## NEW Wiring Colours

The IEE will published Amendment No 2 to BS 7671: 2001 (the IEE Wiring Regulations) on 31 March 2004. The Amendment will specify new cable core colours for all new fixed wiring in electrical installations in the UK. These new colours are sometimes referred to as "harmonised" colours, as they will bring the UK more closely in line with practice in mainland Europe.

### Single-phase Installations

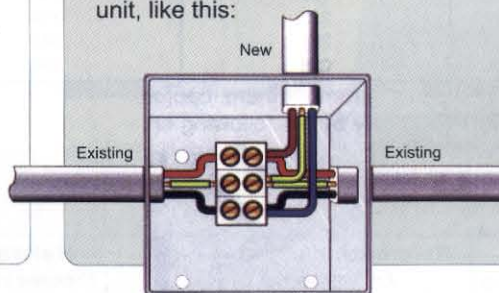
The fixed installation colours of red phase and black neutral are replaced by brown phase and blue neutral, respectively. These are the colours that have been used in appliance flexible cables for many years. The protective conductor is still identified by the colour combination green-and-yellow.

Alterations or additions to a single-phase installation do not require marking at the interface between old and new cabling providing that they are correctly coloured. However a warning notice must be fixed at the distribution board or consumer unit, like this:

### Three-phase Installations

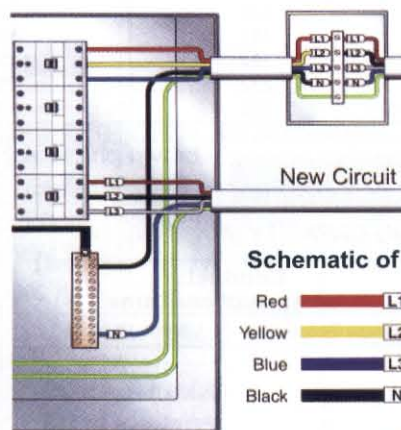
For three-phase cables the phase colours are brown, black and grey, instead of red, yellow and blue, respectively, and the neutral colour is now blue instead of black. Again the protective conductor is identified by the colour combination green-and-yellow. Alternatively all three of the phase conductor cores may be coloured brown and marked L1, L2, L3 at the terminations.

For alterations or extensions to three-phase installations, it is recommended that old and new cables are marked at the interface L1, L2, L3 for the phases and N for the neutral. The marking should be made to both the new and old cables and is preferred to the use of coloured tape. A caution notice is again required at the distribution board.
